Preview Solution CBR-2529-1

Volvo Chassis - Steering Wheel Switch Harness Routing And Clipping - VN (4)

Published 13 November 2025

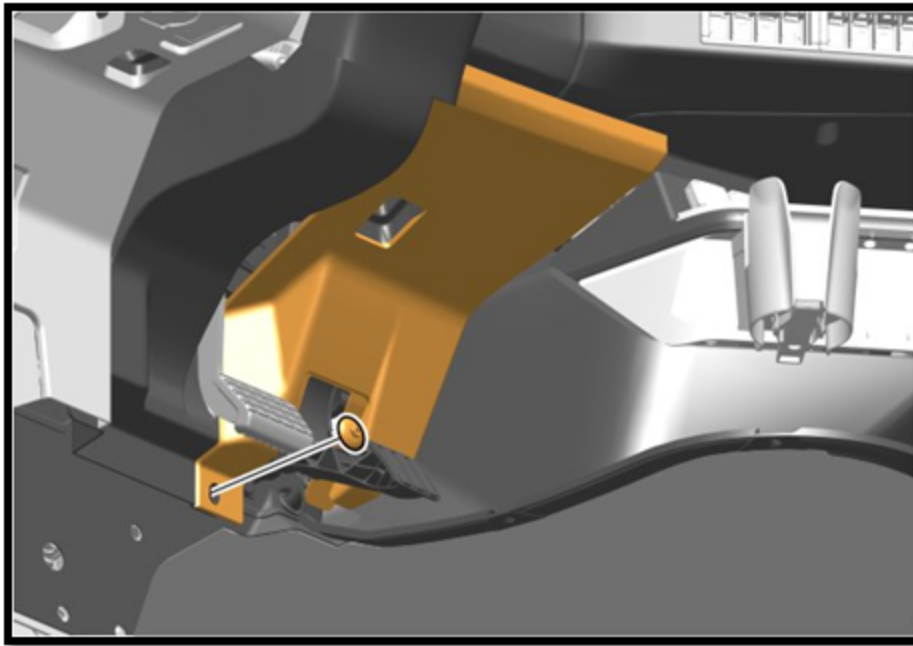
Vehicles may have inadequate Steering Wheel Switch (SWS) harness routing and clipping.

The harness may become unsecure and could be damaged, causing steering wheel switches to become non-functional and/or a vehicle malfunction light.

Use the instructions in the document to inspect the harness for damage and install a routing and clipping bracket to secure the harness.

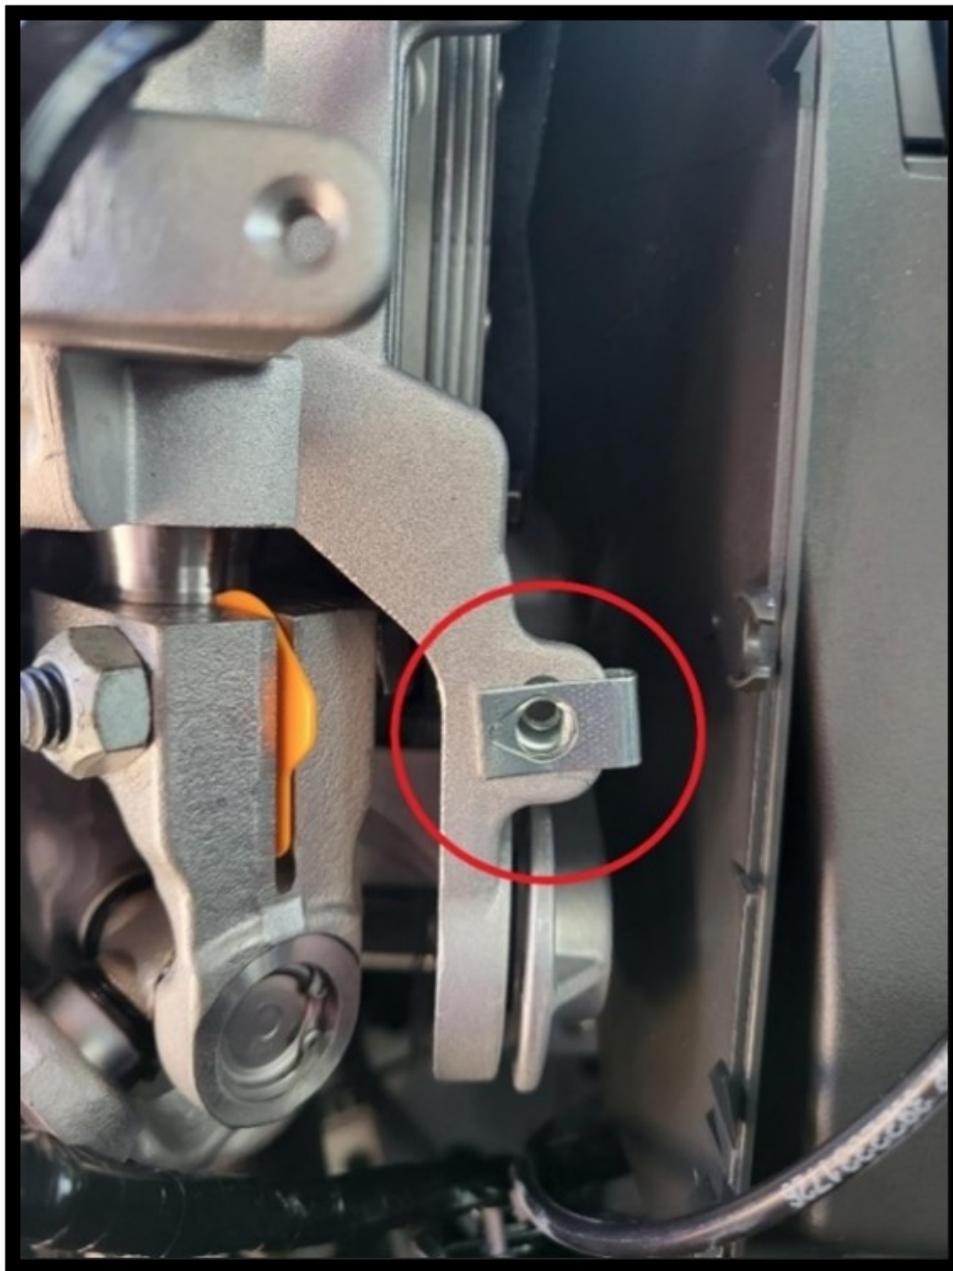
4. Inspect the steering wheel harness for damage caused by contact with the steering shaft.

5. If harness damage is found refer to Impact operation titled "Wiring Repair" under function group 371 to repair the harness. If no damage is found continue to next step.

6. Install spring nut (PN-20399313) in the location circled below. Note: If a cable tie is in the location remove and discard it.

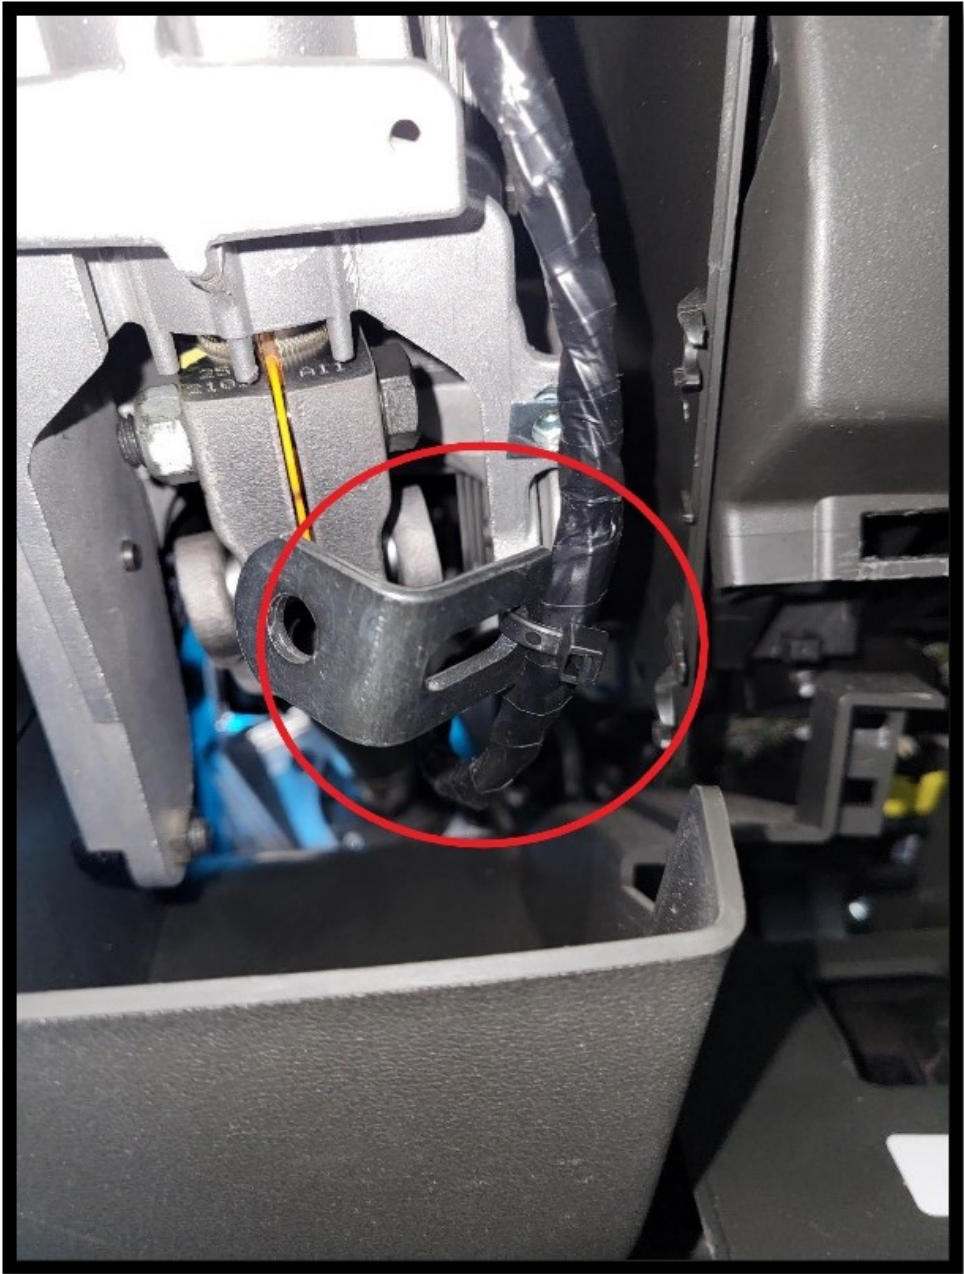
7. Secure harness to bracket (PN-965552) using cable tie (PN-948211) as shown below.

8. Position the bracket and install the screw (PN-994792).

Tightening Torque	
Screw	M5
	6 ±1 Nm (4.4 ±1 lbf·ft)
